SAN ANTONIO WATER SYSTEM <u>HIDDEN SPRINGS</u> <u>WATER PROJECT</u> SAWS Job No. 11-7003 SAWS Solicitation No. B-13-019-DB

ADDENDUM NO.2 March 13, 2013

WATER PLAN DETAILS

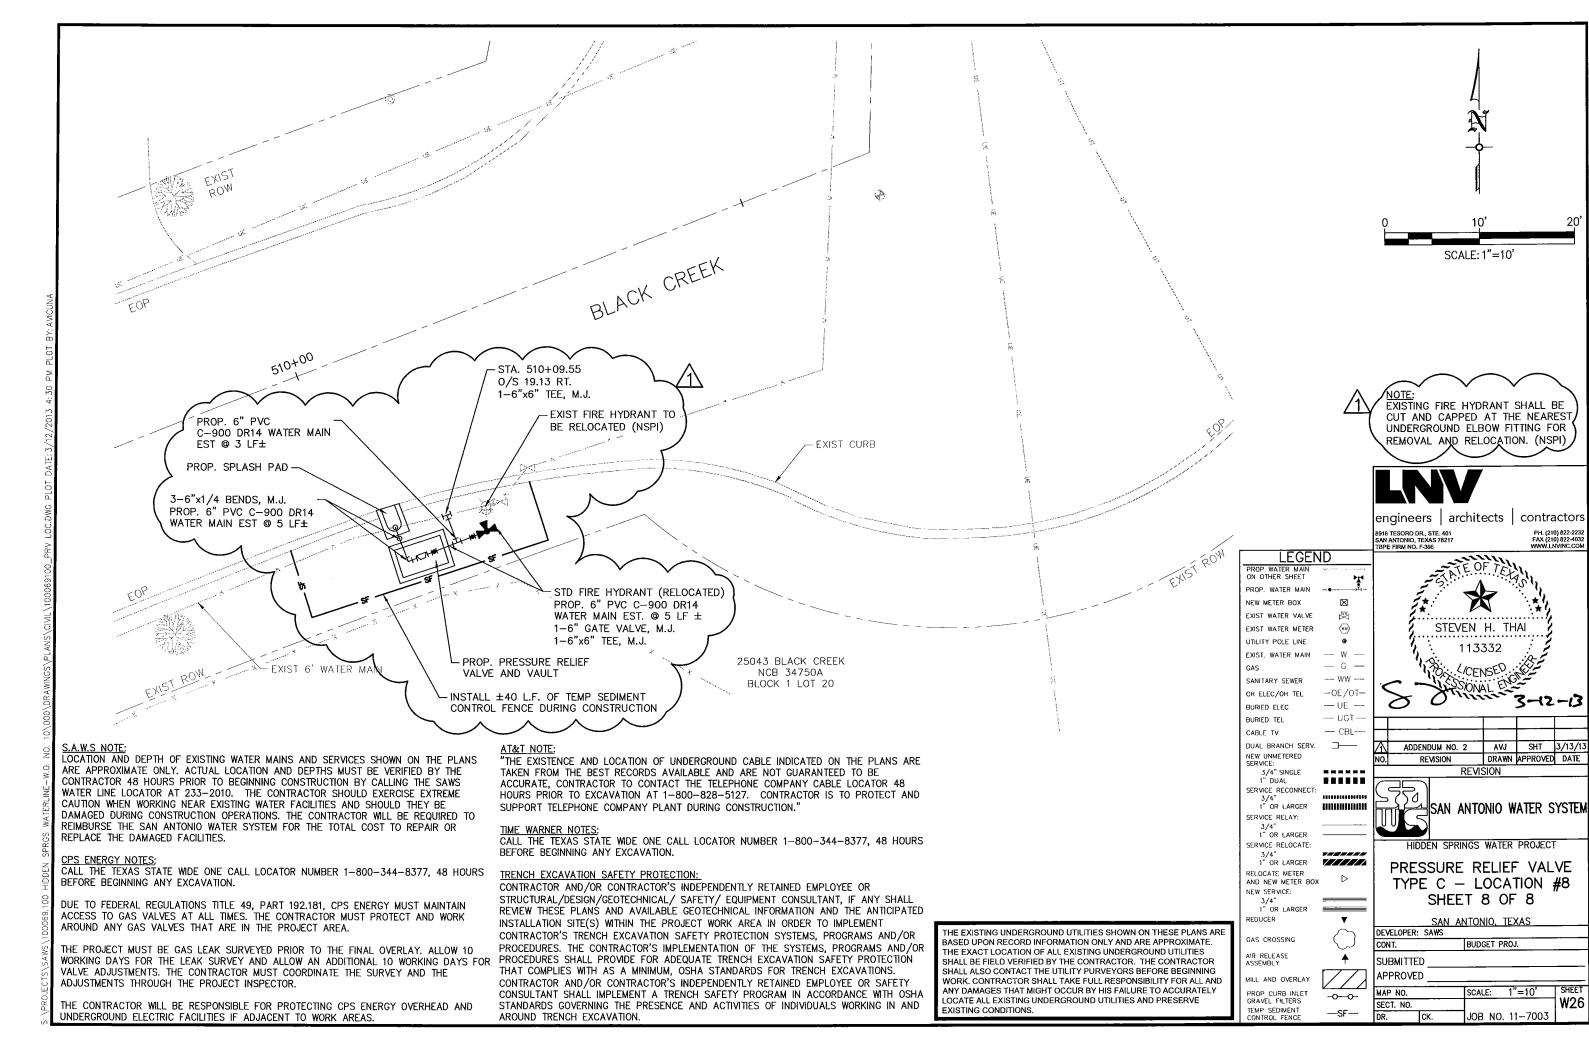
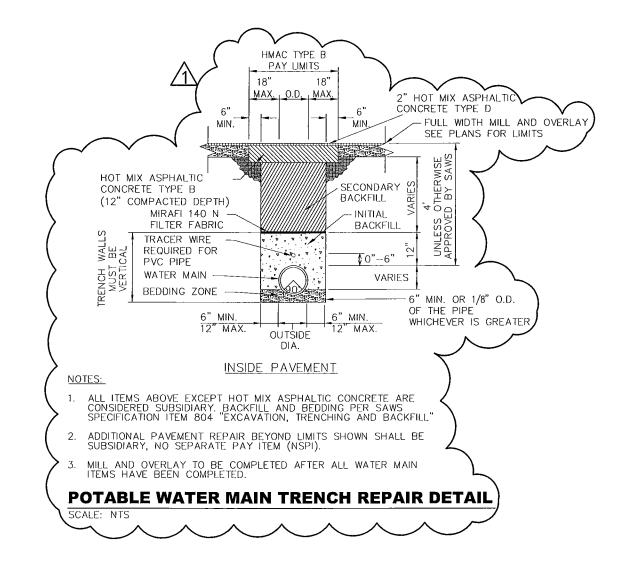
- Q1: There is no trench backfill detail showing the base and surface course requirements in paved areas? Is it possible to get a trench backfill detail showing the limits of the HMAC Type "B" (Item 205.2)

- Q5: Can the engineer please provide a trench detail.
- A5: Yes, see new sheet W29A.
- Q6: Is the contractor going to be allowed to place a port-a-let onsite?

- A1: A trench detail has been provided with new Sheet W29A.
- Q2: I cannot seem to find in the Contract Documents and Technical Specification book where it lists the liquidated damages. Could you please let me know what the liquidated damages are?
